Re: 87 Memorial Parkway  
Block 61, Lot 4

**Re: Zlata (PB20-18)**  
**Bulk Variance Application – Technical Review #1**  
**Location: 87 Memorial Parkway**  
**Zone: OR (Office Residential District)**  
**Block 61, Lot 4**  
**Borough of Atlantic Highlands, Monmouth County, NJ**  
**Our File: HAHP0061.02**

**NO. 87 MEMORIAL PARKWAY**  
 LOCATION LAND SURVEY SHOWING ADDITION TO GARAGE ON LOT 4 IN BLOCK 61 ON THE OFFICIAL TAX MAP OF THE BOROUGH OF ATLANTIC HIGHLANDS, MONMOUTH COUNTY, NEW JERSEY  
 TAX MAP PAGE 13  
 THOMAS CRAIG FINNEGAN LAND SURVEYING, LLC  
*Thomas Craig Finnegan*  
 THOMAS CRAIG FINNEGAN LIC. # 38601  
 PROFESSIONAL LAND SURVEYOR  
 245 EAST END AVENUE, BELFORD, N.J. 07718  
 Office 732-787-0318, Cell Ph. 732-856-2821  
 FAX # 732 495-6217, Thomascfinnegan@gmail.com  
 SCALE 1" = 20' APRIL 28, 2022

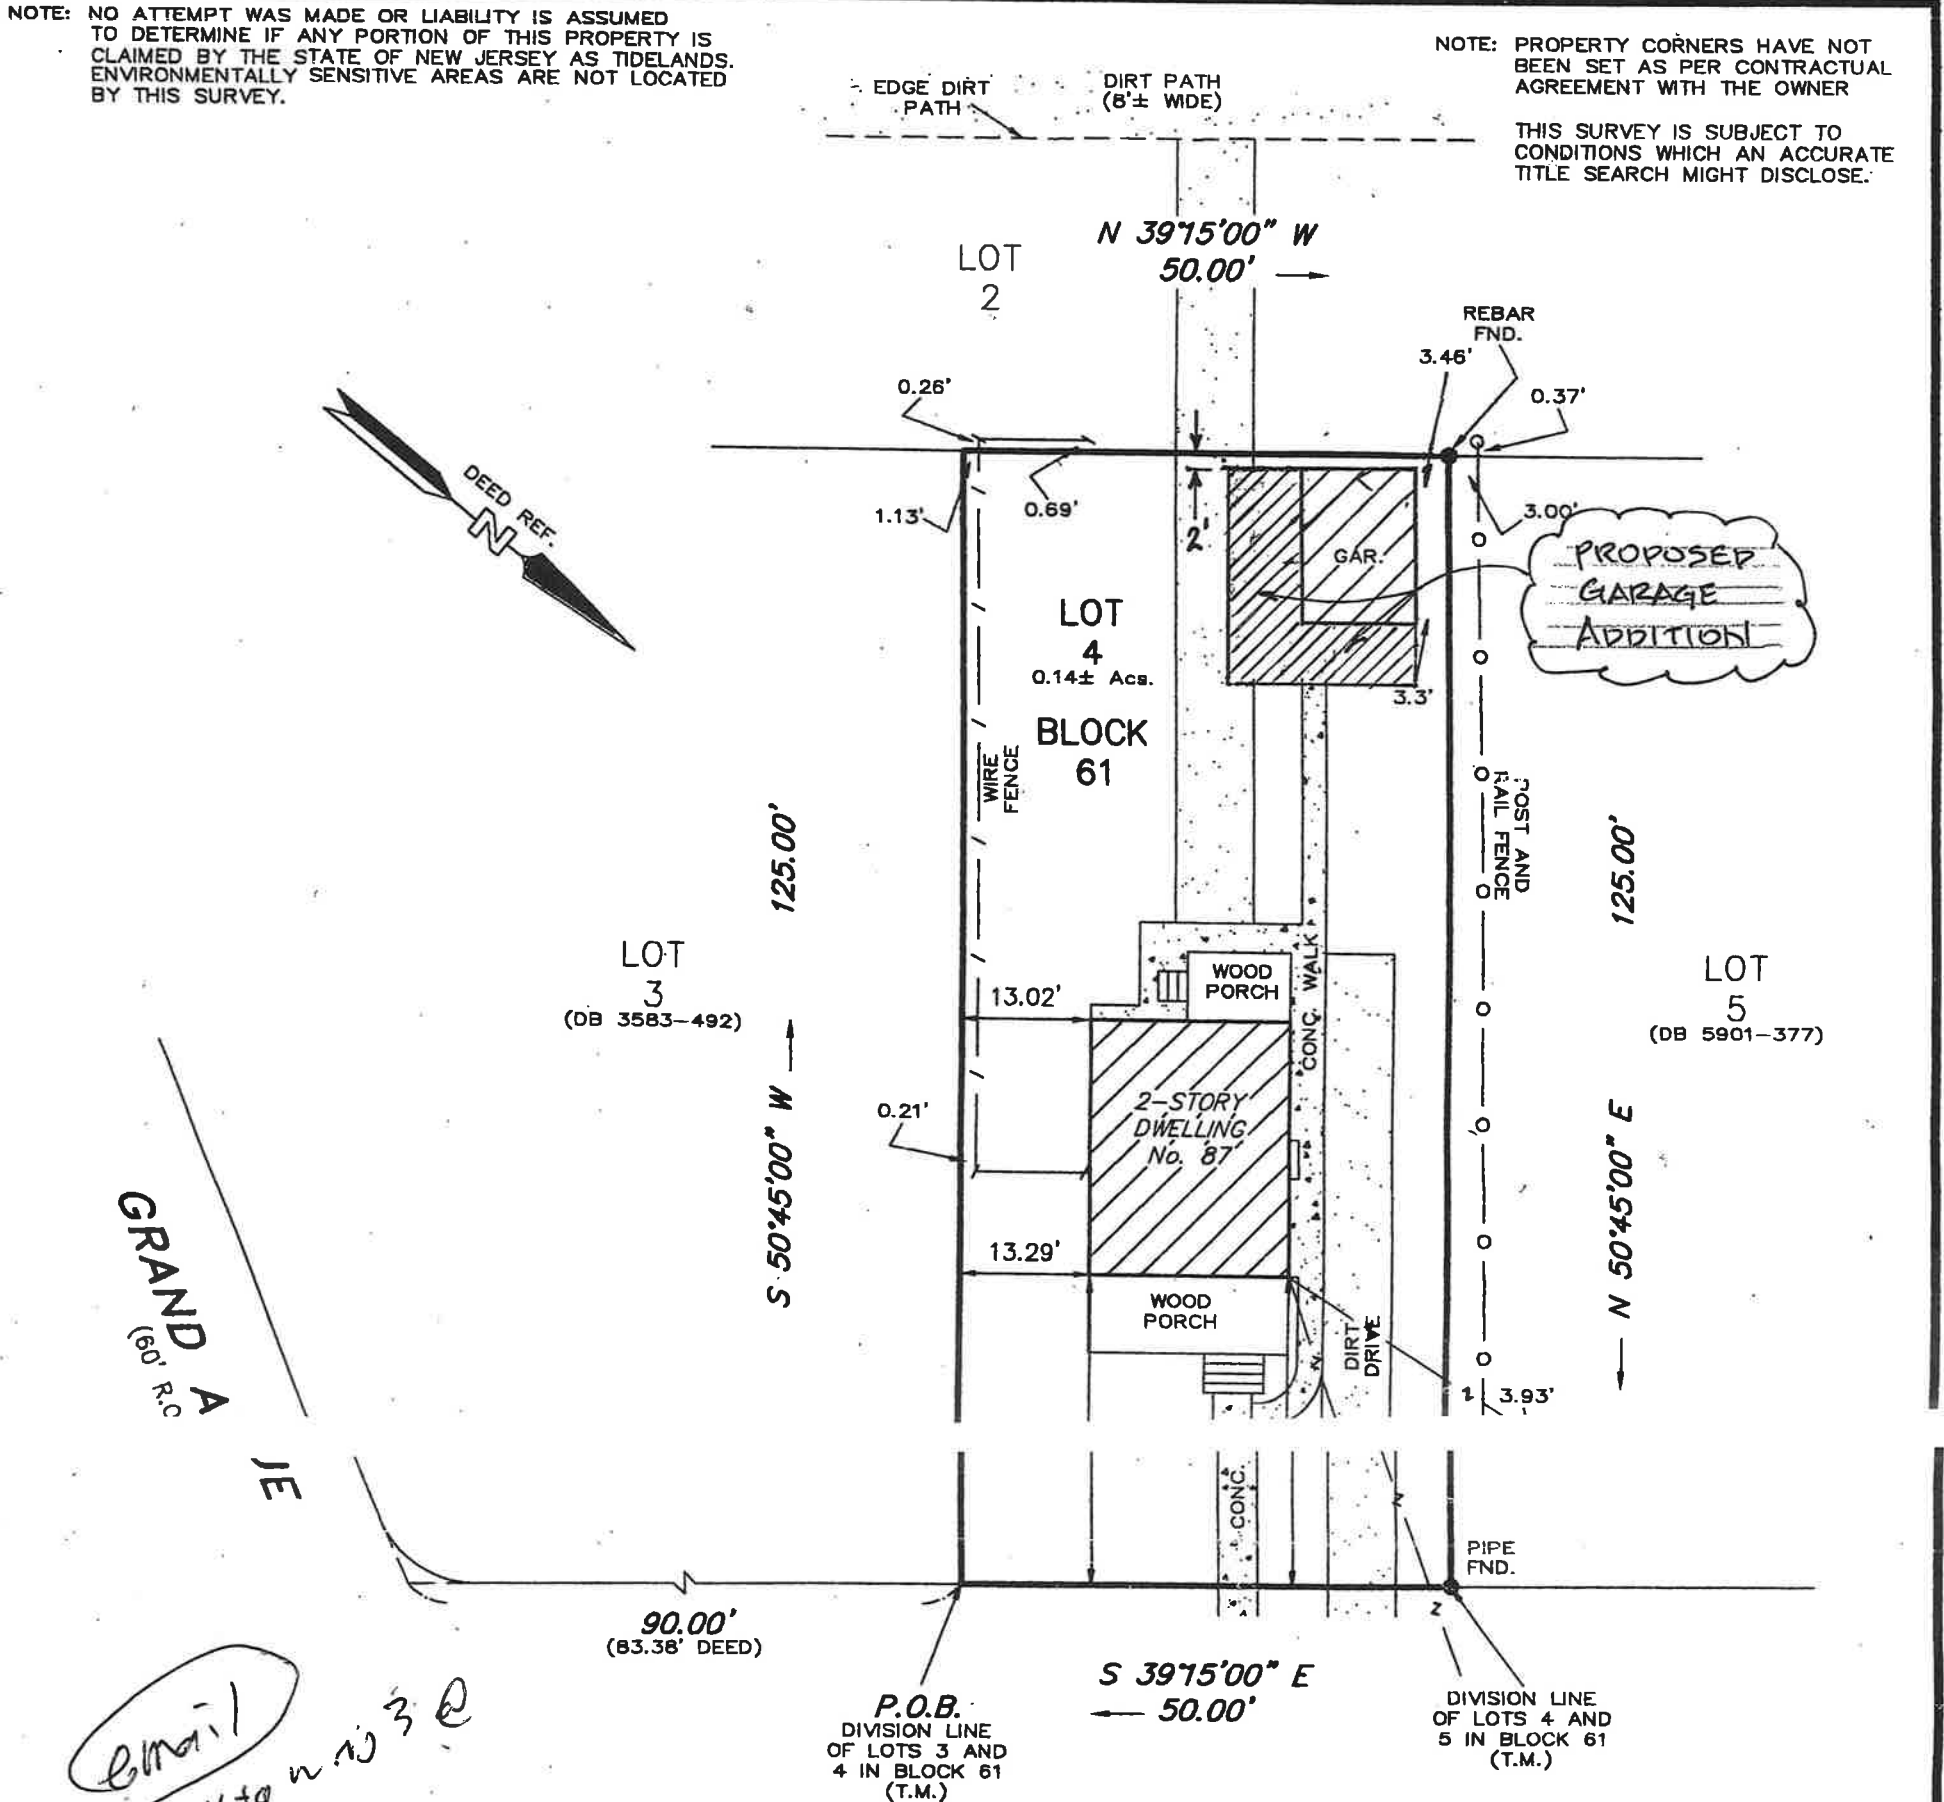
7. The following information is required to be submitted prior to the application being deemed complete for review and public hearing:
- a) Per the survey dated April 28, 2022, expansion of the structure is proposed approximately 1 foot over the rear property line on Block 61 Lot 2. The previously provided survey, dated June 6, 2000, shows a 2' setback from the rear property line. Applicant to clarify property boundaries and work location.

- b) Owner of Lot 2 must co-sign the application or otherwise formally approve the proposed encroachment.
  - c) Applicant should provide clarification for expansion of the existing garage structure in lieu of full demolition and replacement in a conforming location. Applicant to confirm which portions of the existing structure are to remain and if any clearing, driveway expansion, or other work is proposed.
  - d) The Applicant should provide site photos depicting existing conditions.
  - e) The existing principal and accessory building heights should be clarified.
8. Based upon our review of the subject application, we estimate that the following fees are required:

GARAGE RENOVATION & ADDITION

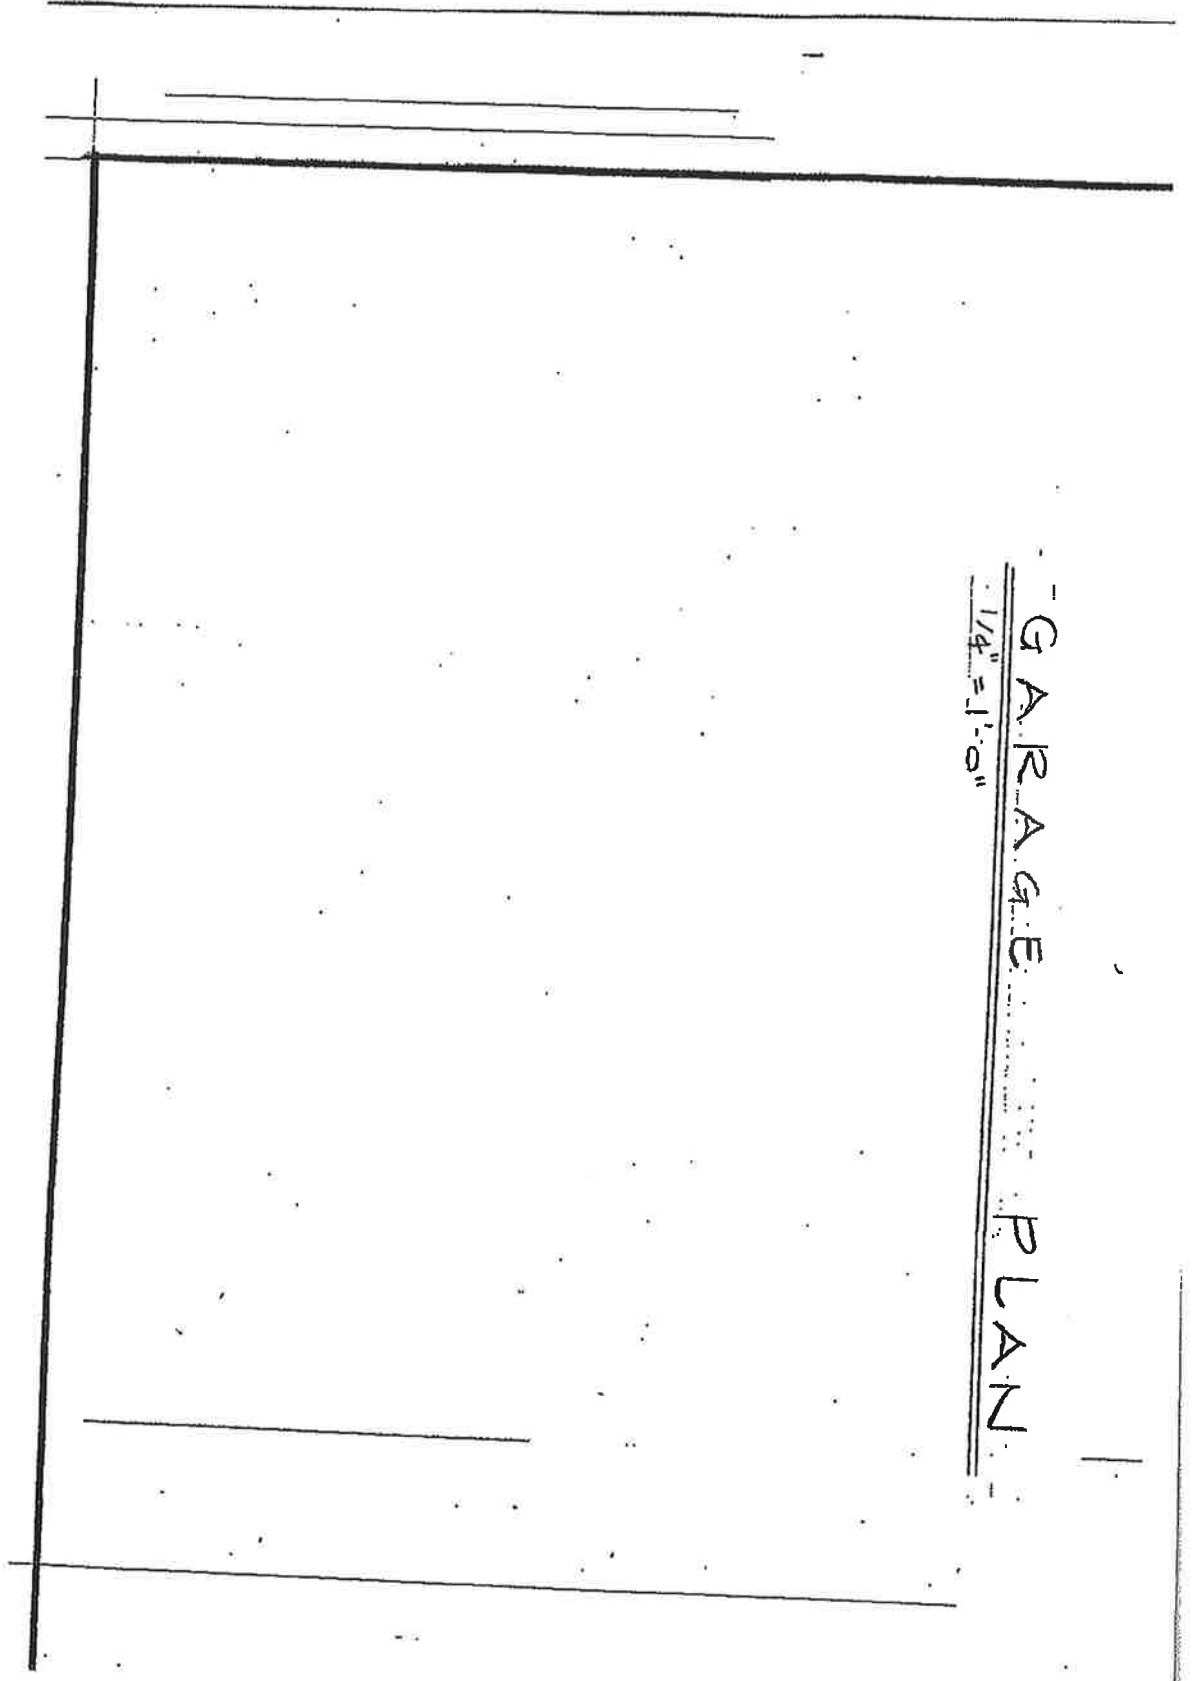
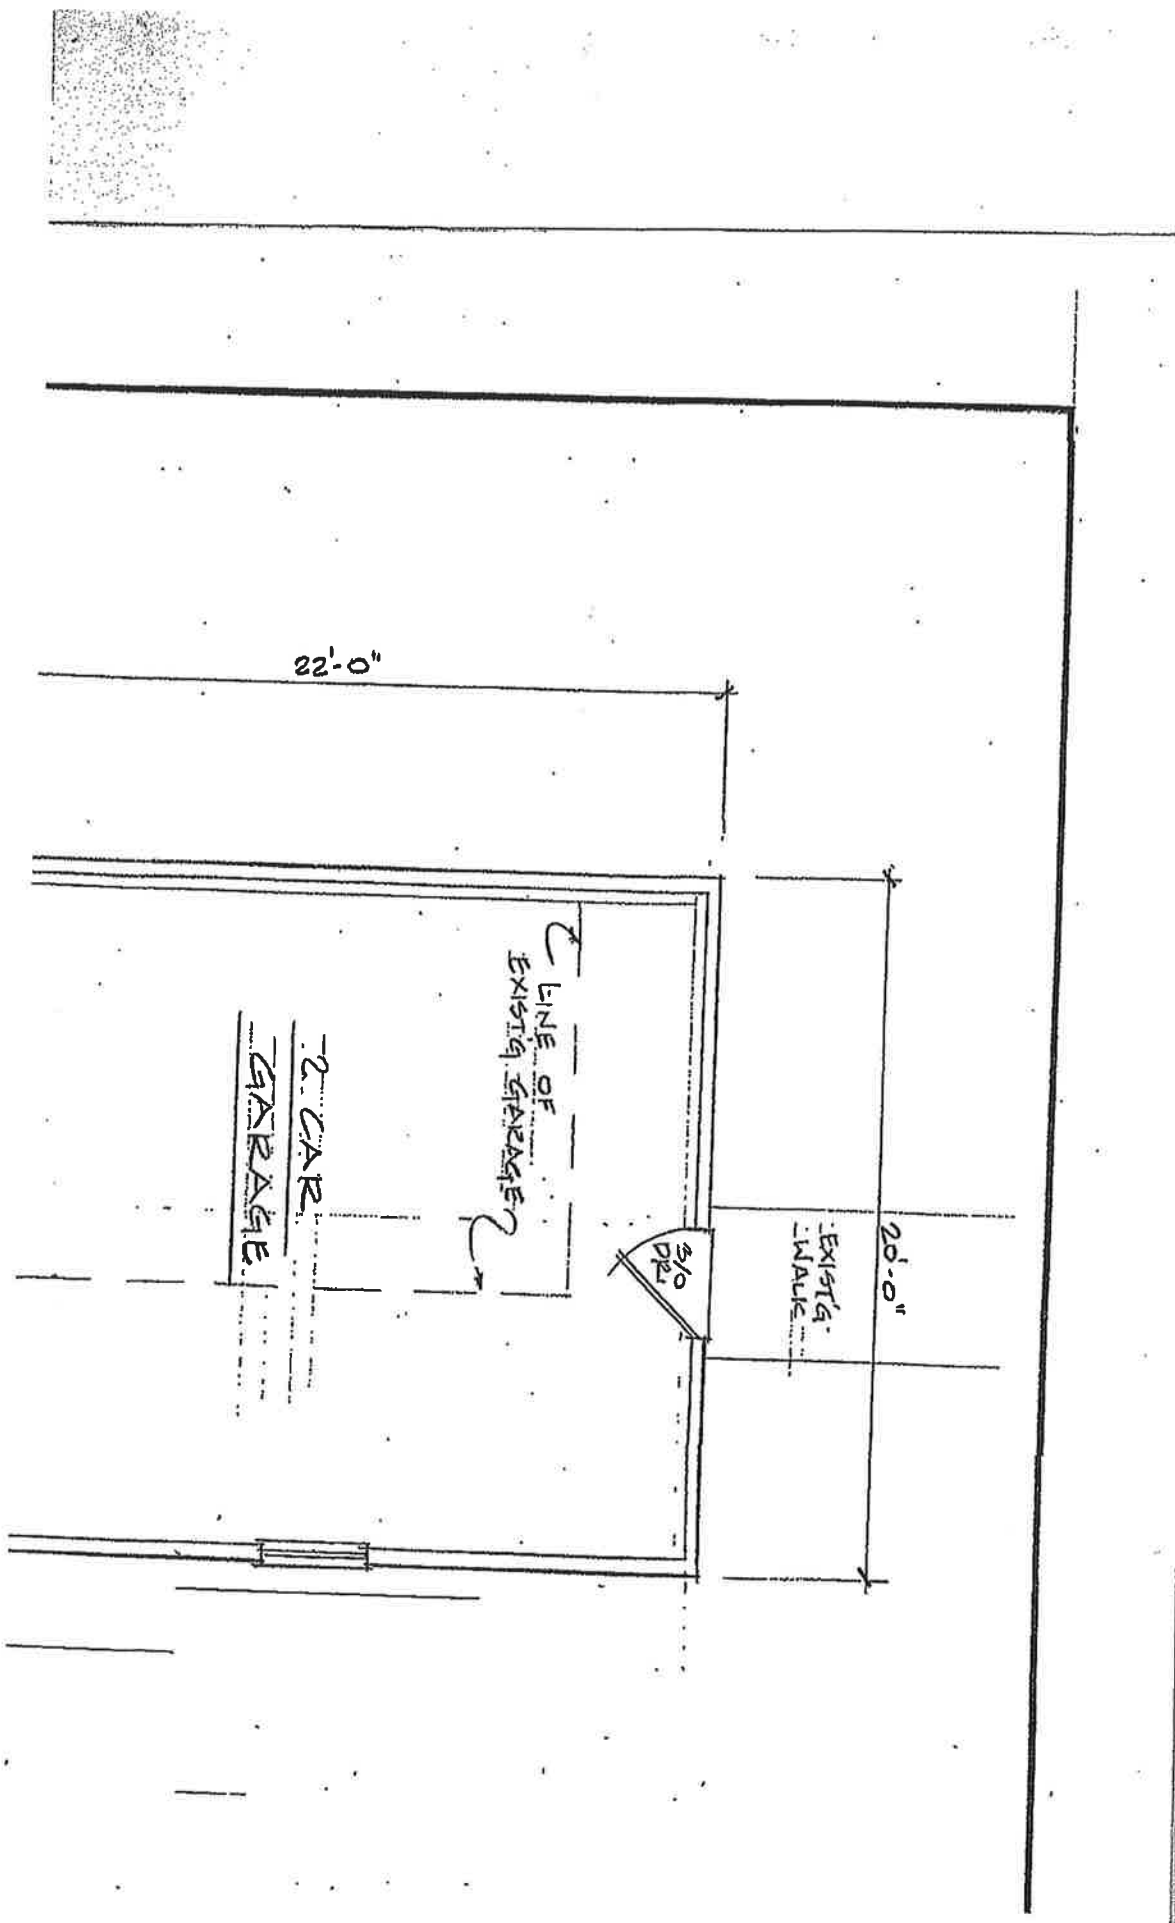
- a) **Section 150-72(A)** – The maximum private garage space is one (1) motor vehicle per 5,000 feet of lot area, whereas the Applicant proposes two (2) spaces for a 6,250 SF lot. Additionally, the maximum height of private garage is 16 feet, whereas the Applicant proposes 16.17 feet.

- d) **Section 150-29(A)(2)(Exhibit 5-2)** – The maximum allowable accessory building height is 16 feet, whereas 16.17 feet is proposed.
5. It appears that the following existing non-conformities would remain with respect to this Application.

- h) Applicant should discuss existing and proposed building height for the garage structure.
- i) Applicant should provide site photos depicting existing conditions.
